SERVICE BULLETIN

M-1153

Safety Recall Code 0114

RECALL CODE 0114 - TAILLAMP BULB REPLACEMENT

Figure 3. Talllamp Bulbs

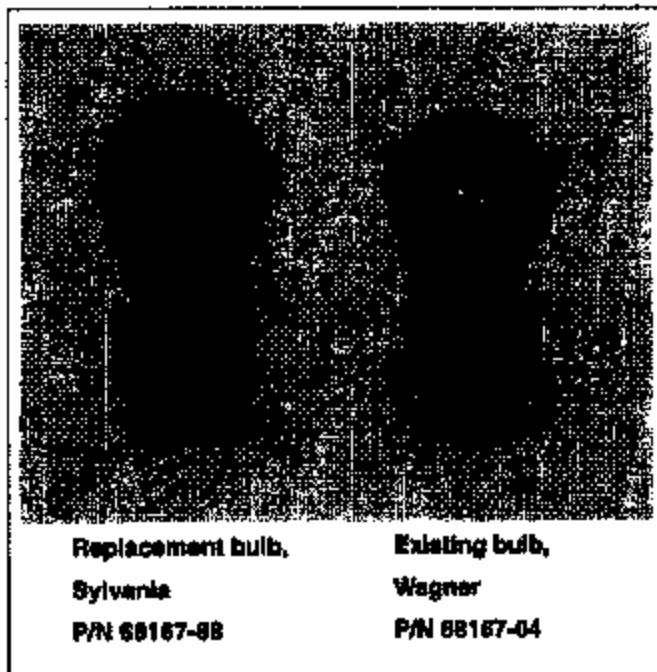
See Figure 3. Both bulbs in Figure 3 were identified as Part No. 68167-98. In January, 2004, the Wagner bulb with the filament support was changed to Part No. 68167-04. Make certain dealer technicians and parts personnel use the correct bulb for future bulb replacements.

See Figure 3. Identify any bulbs in your dealer parts inventory which are the Wagner design and are labelled with the earlier 68167-88 Part No. Relabel these bulbs as Part No. 68167-04 and relocate in an appropriate bin location.
